# Warranty Field Campaign

<b>Campaign Number:</b> c2053	<b>Revision:</b>	<b>Released Date:</b> 28-Sep-2018
<b>ISX12 CM2350 Emissions Recall Campaign</b>		<b>Expiration Date (U.S. and Canada):</b> 28-Sep-2023
		<b>Expiration Date (International):</b> 28-Sep-2023

# Technical Service Bulletin

<b>Technical Service Bulletin:</b> TSB130099	<b>Released Date:</b> 15-Apr-2015
<b>Engine Control Module (ECM) Calibration and Aftertreatment Selective Catalytic Reduction (SCR) Catalyst Compatibility</b>

Figure 1, Aftertreatment SCR Catalyst Heat Shield Dimples

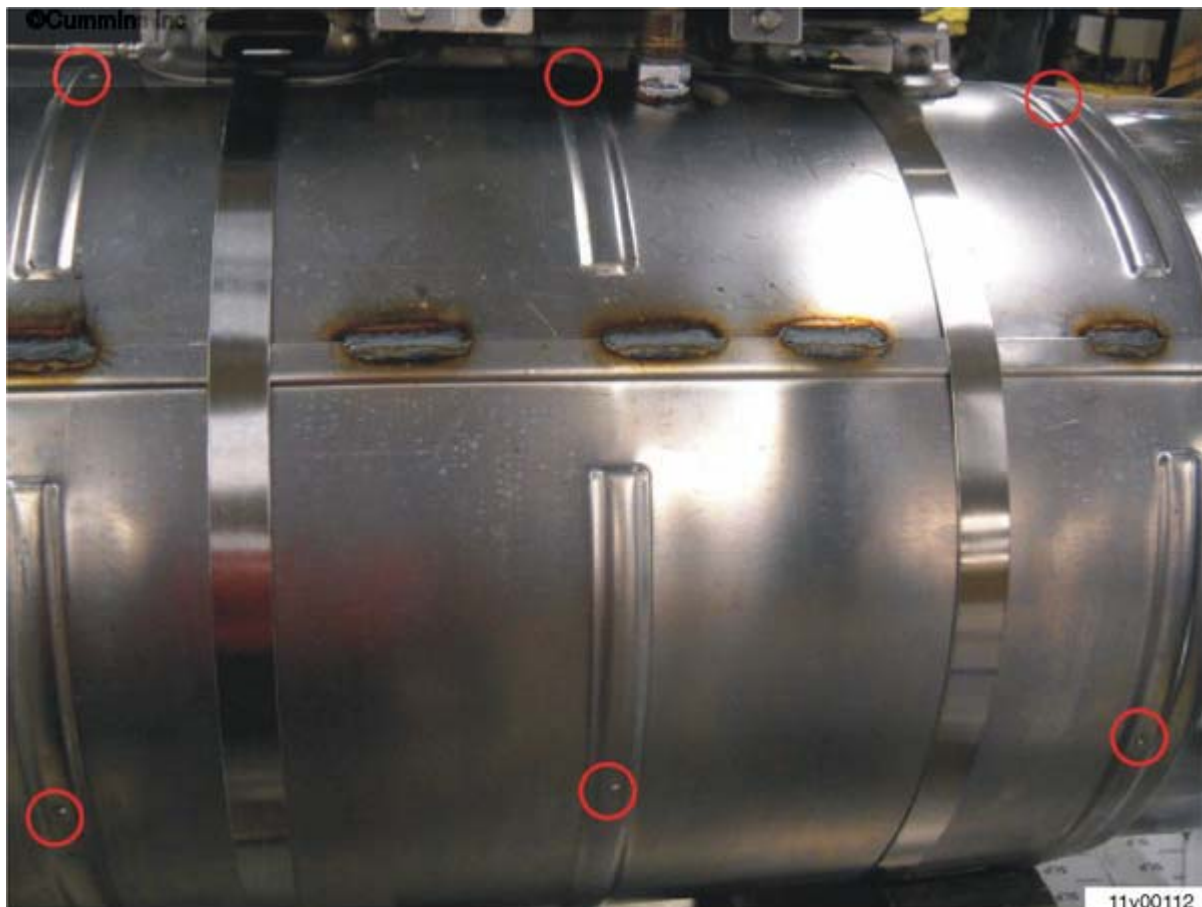
Aftertreatment SCR catalysts that are compatible with ECM calibrations released after June 21, 2013 can also be visually identified by dimples in the aftertreatment SCR catalyst heat shield. These dimples go around the circumference of the aftertreatment SCR catalyst heat shield and can be found in three different locations equidistant around the circumference. See Figure 1.

1. For ISX12 CM2350 (Model Year 2013 Product) engines only, the SCR catalyst must be inspected per TSB130099 prior to performing the campaign. If the SCR catalyst does not have the dimples shown in the TSB, install a new SCR catalyst. If the SCR catalyst has the dimples shown in the TSB, the SCR catalyst does not need to be replaced. File only the ADMIN Time (00-90x) and the Campaign Check (17-902) to close the eligibility for the subject ESN.
2. Refer to procedure SCR Catalyst Remove and Install in section 011-036 of manual 4310646 (ISX12 CM2350 X102).
